# Metropolitan Development Commission Plat Committee (July 9, 2025) Meeting Agenda

July 9, 2025

<b>Case Number:</b>	2025-PLT-010
<b>Property Address:</b>	1421 East Michigan Street ( <i>Approximate Address</i> )
<b>Location:</b>	Center Township, Council District #13
<b>Petitioner:</b>	Indy Real Estate Consulting, LLC, by Justin and David Kingen
<b>Zoning:</b>	D-8
<b>Request:</b>	Approval of a Subdivision Plat to be known as Replat of Lot 6 of North Arsenal Park Addition, dividing 0.14-acre into two lots.
<b>Waiver Requested:</b>	None
<b>Current Land Use:</b>	Two-Family Dwelling
<b>Staff Reviewer:</b>	Noah Stern, Senior Planner

**2025PLT036 ; Plat**

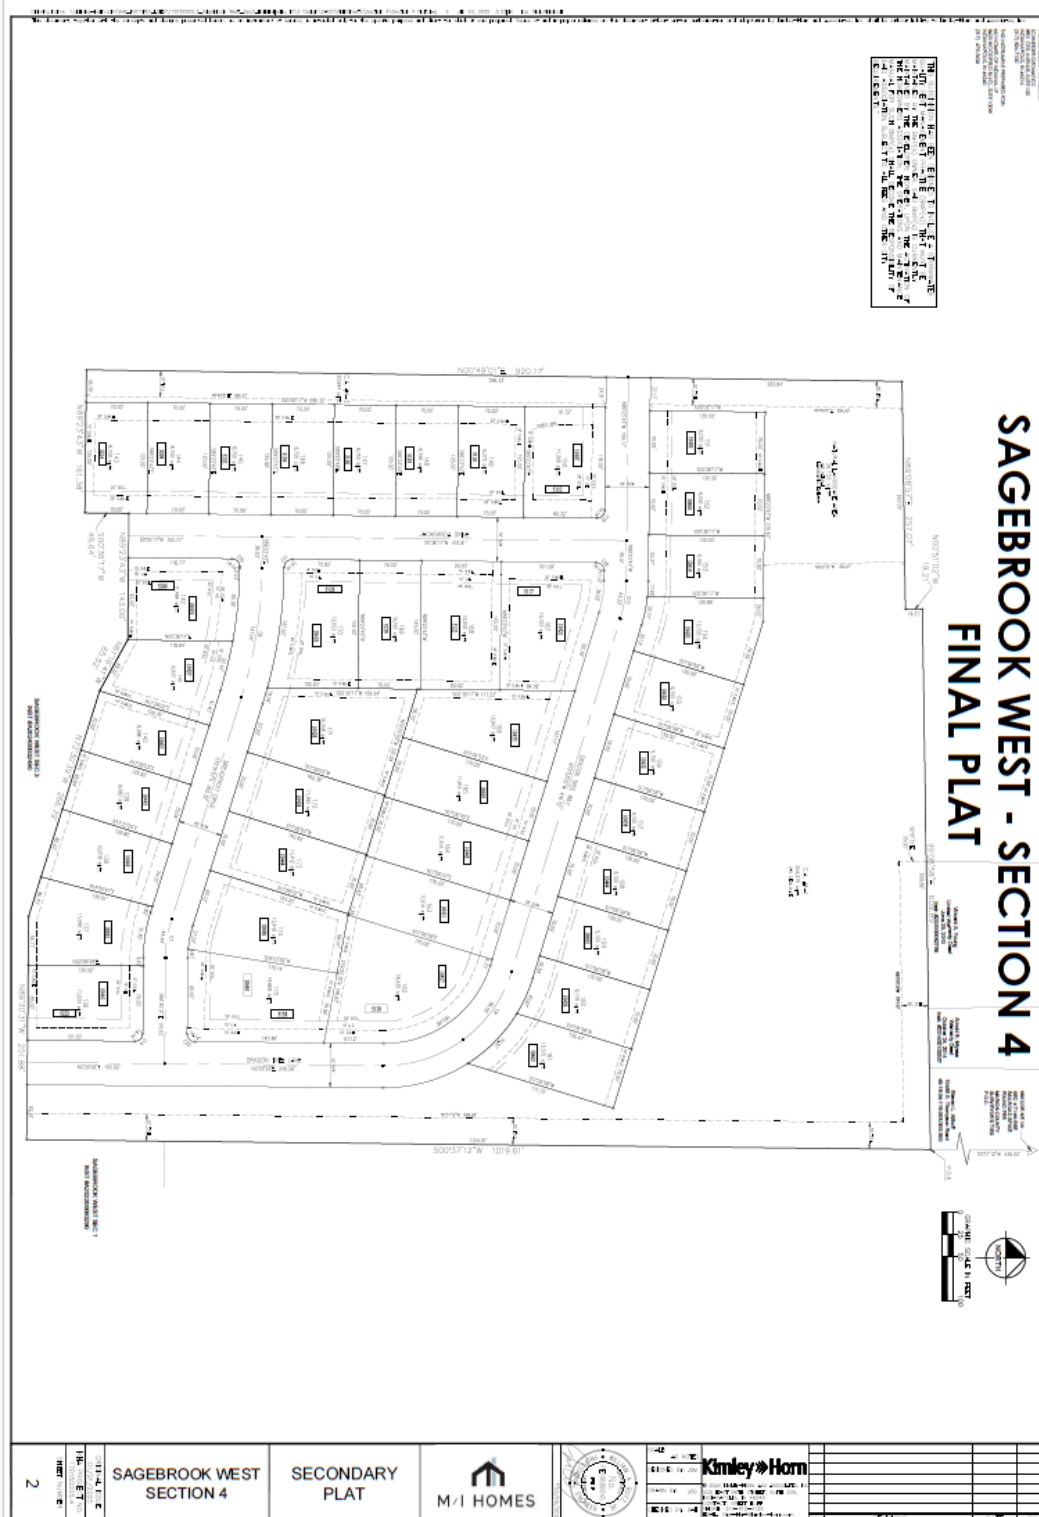
New internal streets would be created in association with this plat: Breadfruit Drive and Dragon Tree Way (with stub connection to the west) would be developed in addition to extensions of the existing roads Dragon Tree Lane and Jacaranda Drive from the previous subdivision section.

Sidewalks are required along the internal streets that would be created and extended by this petition. The Final Plat would need to show placement of those sidewalks per the above Condition #13.

10. That the plat restrictions and covenants, done in accordance with the rezoning commitments, be submitted prior to recording the Final Plat.
11. That all the standards related to secondary plat approval listed in Sections 741-207 and 741-208 of the Consolidated Zoning and Subdivision Ordinance be met prior to recording the Final Plat.
12. That a Topographic Map, Traffic Control Plan, and Natural Infrastructure Plan be submitted prior to recording the Final Plat.
13. That the location of required sidewalks along new internal roads be affixed to the Final Plat.

**2025PLT023 ; Proposed Plat (page 1 of 2)**

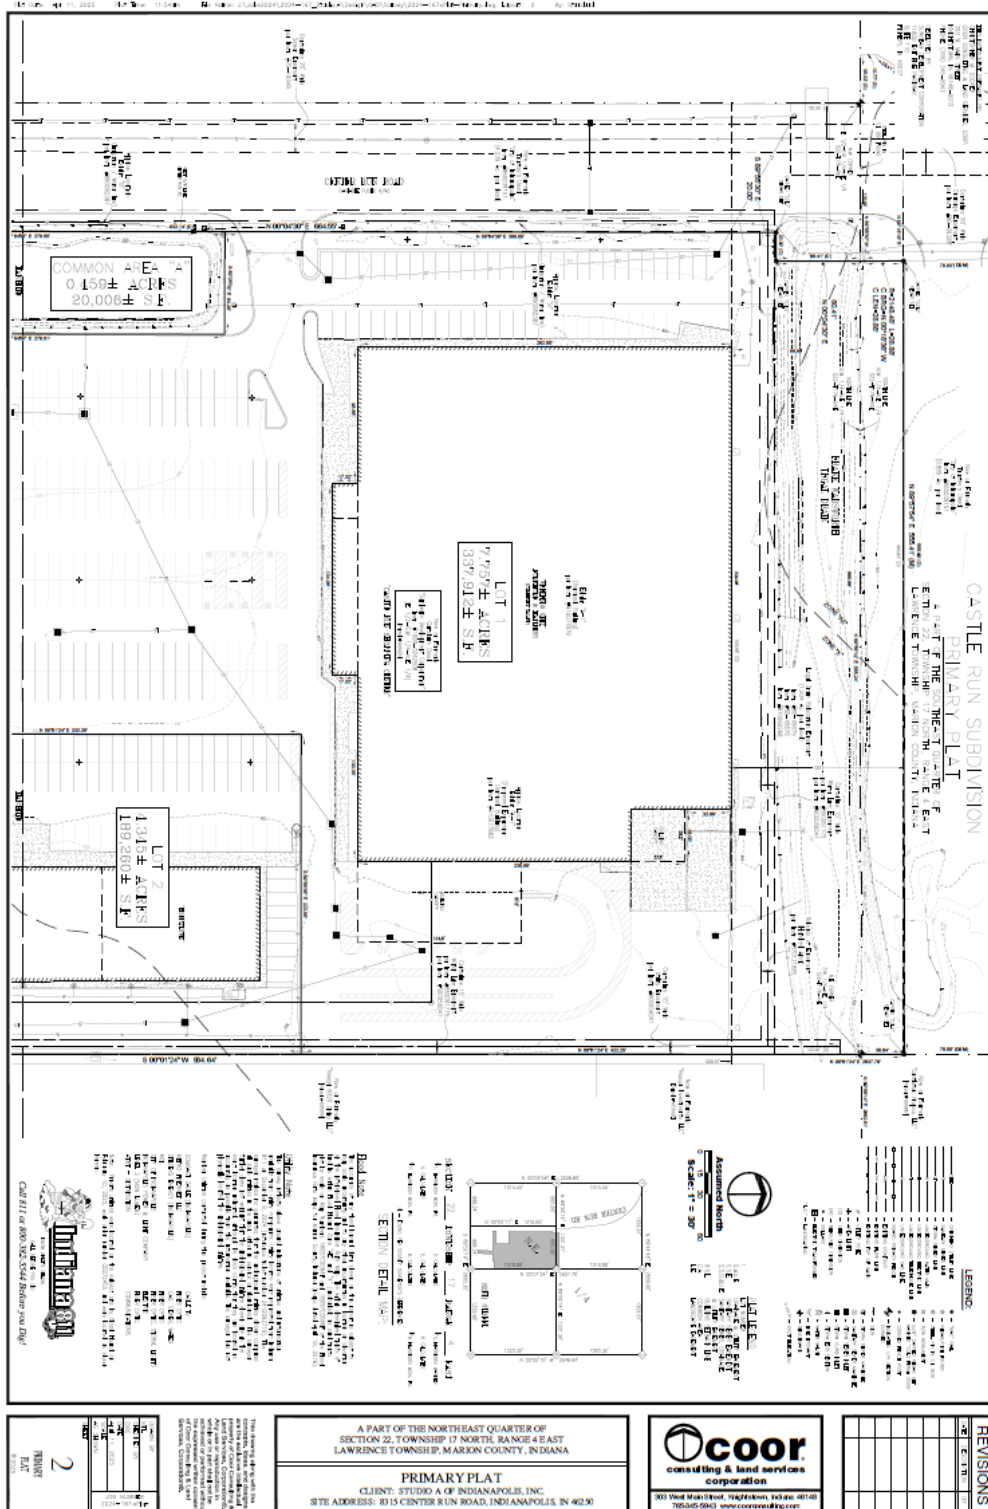
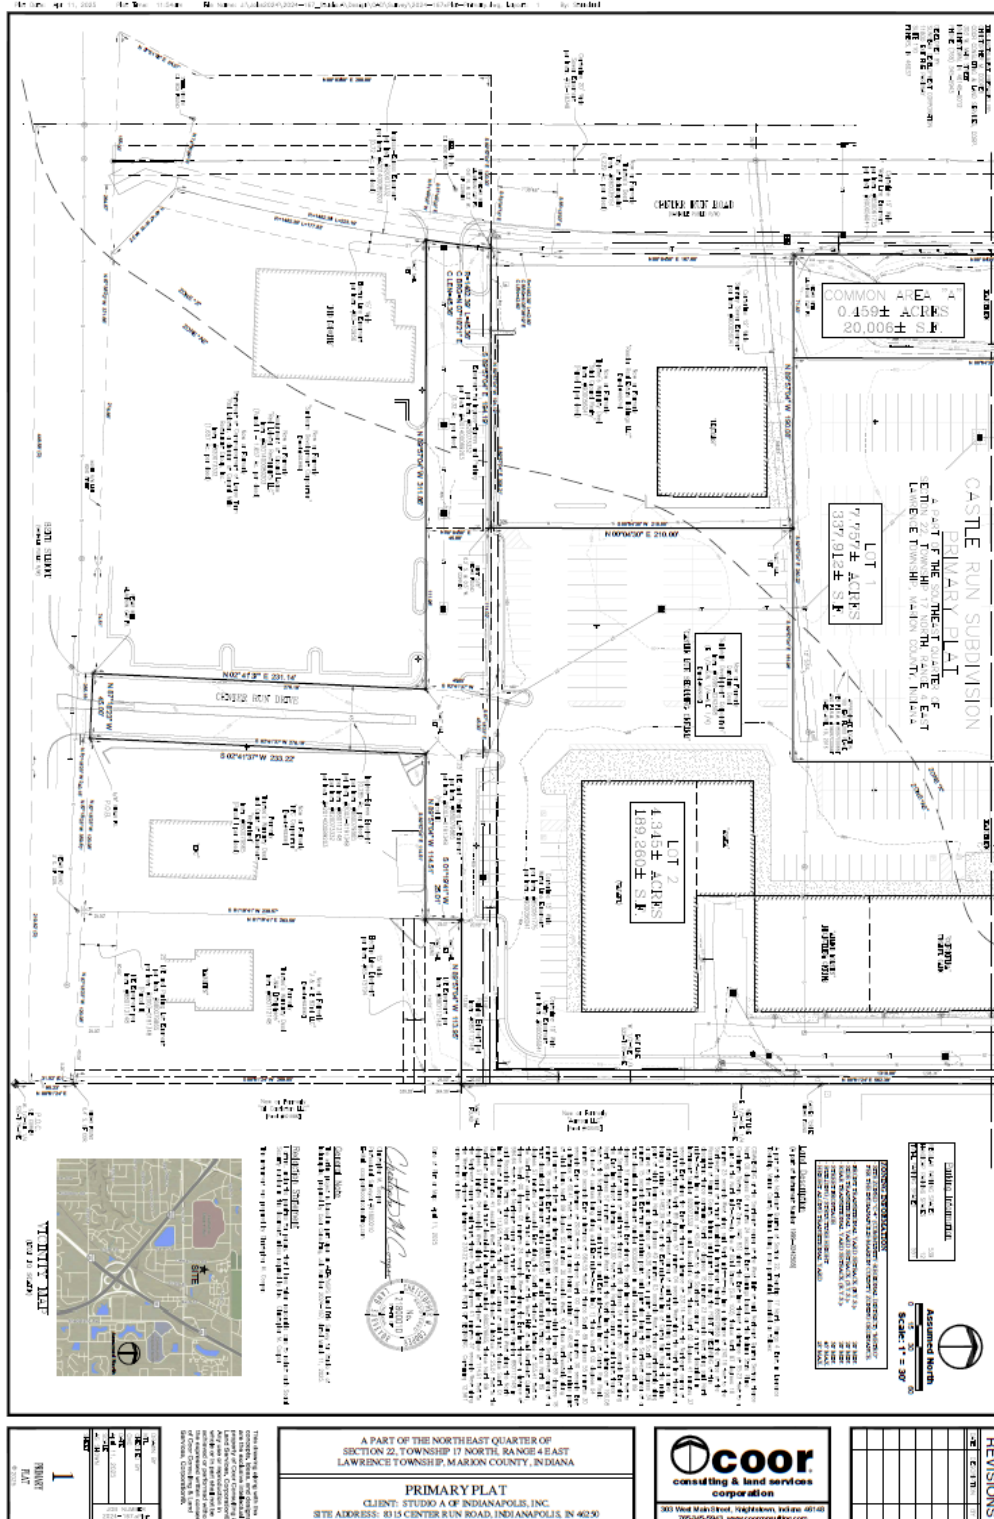
Waivers of sidewalk requirements are appropriate in areas of extreme topography or other special circumstances. Staff notes that the Department of Public Works has plans for a future daylighting and culvert replacement project for the 125-foot portion of the site comprised by the Howland Ditch legal drain and easement which would involve placement of sidewalks (see Exhibits). Staff would be supportive of a waiver of the sidewalk requirements for this 125-foot portion of the frontage.

Although the Findings provided by the applicant are correct that the two outlots existing between their portion of the frontage and sidewalks along 82<sup>nd</sup> Street do not currently contain sidewalks, it does not appear that past development on either property has been exempted from the need for sidewalks via ‘in lieu of’ payments into the City’s sidewalk fund as outlined within 744-301.G of the Ordinance, and future redevelopment would offer opportunities for their installation and for greater usage of existing north-south crosswalks across 82<sup>nd</sup> Street.

Additionally, the Comprehensive Plan indicates plans for a future greenway in this area, and the Castleton Strategic Revitalization Plan (2020) both encourages the addition of pedestrian trails and paths to promote walkability in a general sense and envisions future development of a greenway with associated residential development in areas along the Howland Ditch and to the west of the property (see Exhibits). Staff is supportive of these plans and feels that required installation of sidewalk in this area would be a long-term benefit both for existing apartments to the north and potential future residential development to the west. Staff therefore recommend that the sidewalk waiver request be denied, except for the 125 linear feet closest to the northern property line.
